MECKLENBURG COUNTY HEALTH DEPARTMENT

APPLICATION FOR PERCOLATION TEST

SUBJECT: APT #7047 (S & T Development Company)
Lot No. 14, Reverdy Lane
Reverdy Woods Subdivision
1-7-74

PERCOLATION TEST REPORT

PLOT PLAN

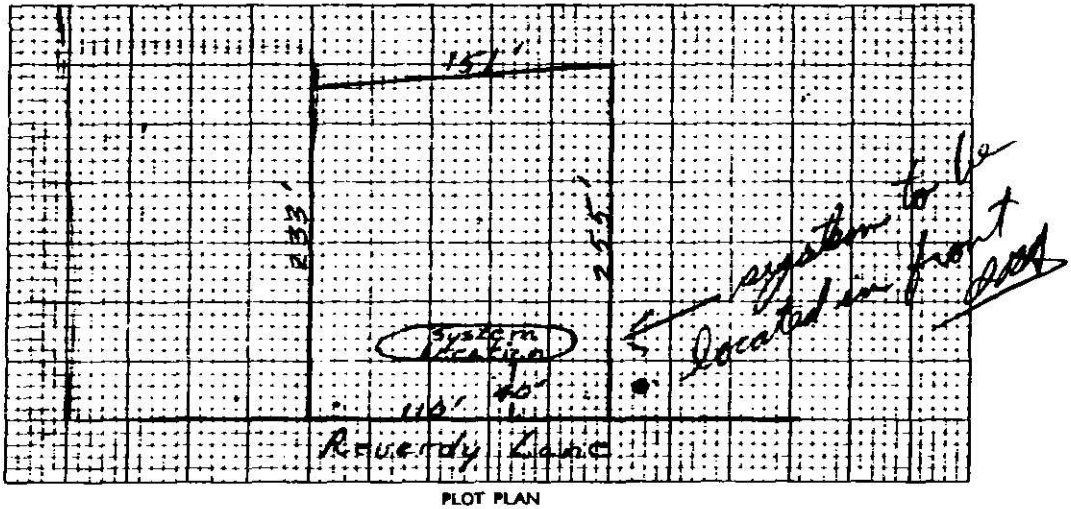
Soils were found to be of the Pacolet series. These soils have good drainage, good aeration and moderate permeability.

Topography is extremely limiting on the rear of the lot (away from Reverdy Lane). The system should be installed on the front of the lot (adjacent to Reverdy Lane). A sewage pump will probably be required to get the effluent to the absorption field.

It is recommended that the lot be granted approval for installation of a septic tank system. Design should be based on a 60 min./in. perc. rate.
